CIVIL ENGINEERING REPORT

# IC3 Super West

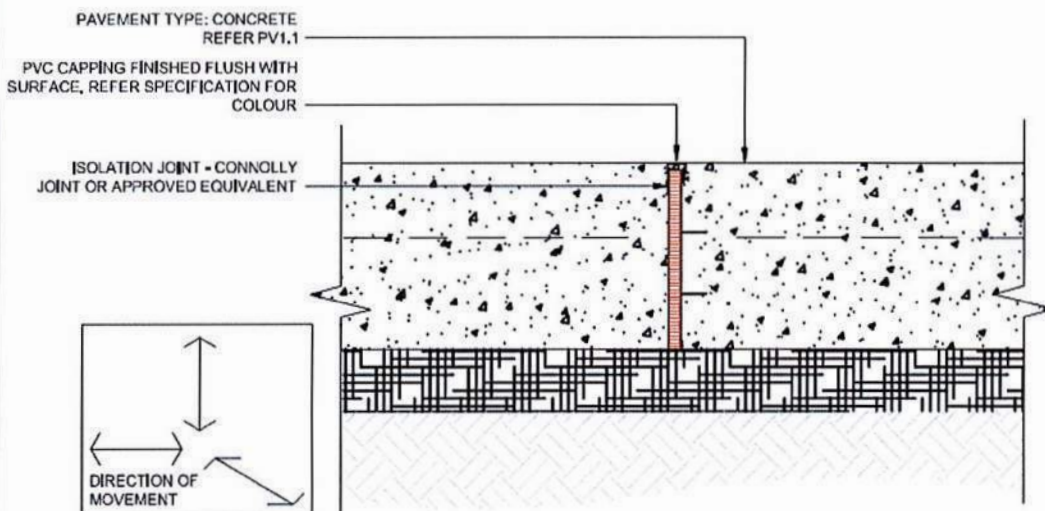
**NOTES:**  
REFER JOINTING PLAN FOR SETOUT & JOINT TYPE / LOCATION.  
ALL SURFACE JOINTS AS INDICATED ON FINISHES PLANS,  
SEEK CLARIFICATION IF REQUIRED

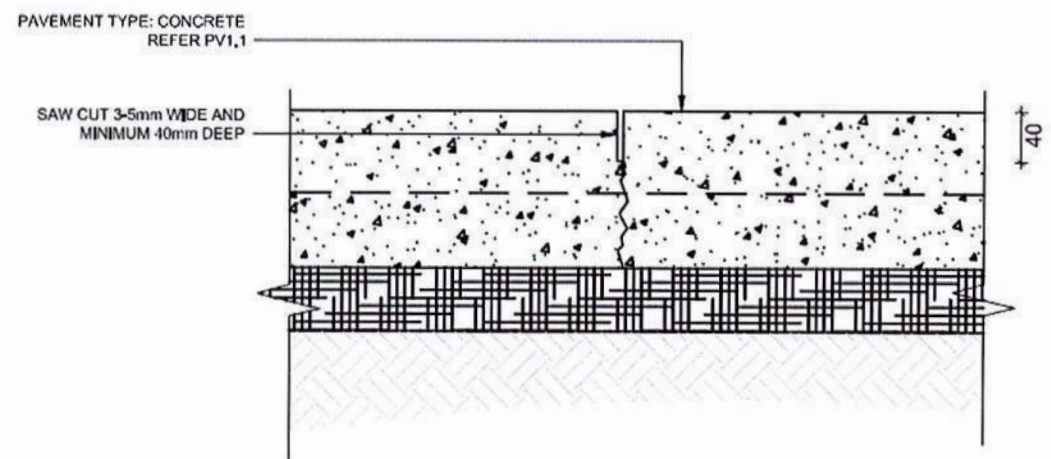
**NOTES:**  
REFER JOINTING PLAN FOR SETOUT & JOINT TYPE / LOCATION.  
ALL SURFACE JOINTS AS INDICATED ON FINISHES PLANS, SEEK  
CLARIFICATION FROM COUNCIL'S LANDSCAPE ARCHITECT IF  
REQUIRED
